Access Compliance Report

Public Rights-of-Way

Intersection ID: 31602	Main Street: BULL_RUN_RD	Cross Street: FERNSPRAY_RD	Location: SW
ADA ID: F1F036E6CC25	Ramp Type: PerpDiag	Initial Pass/Fail: Pass	Overall Compliance: No
		Severity Score: 20

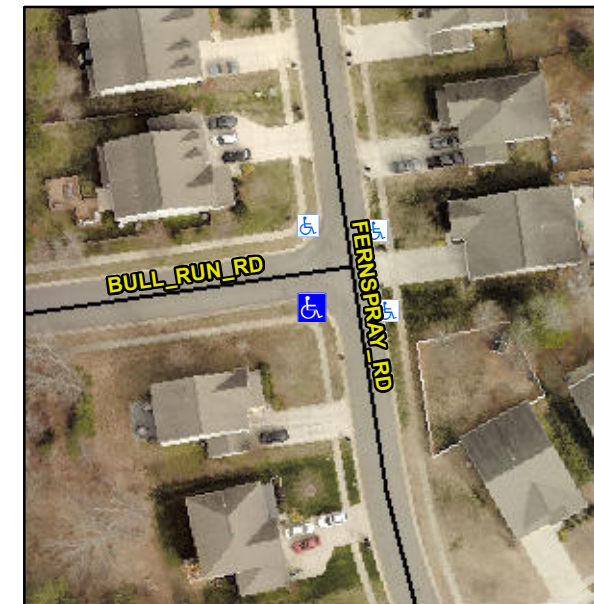
Not Found, R304.2.2-Perp, R304.3.2-Para, R302.7.2, R304.5.4

Remove & Replace Curb Ramp With Two New Directional Ramps or Equivalent. Remove & Replace Gutter.
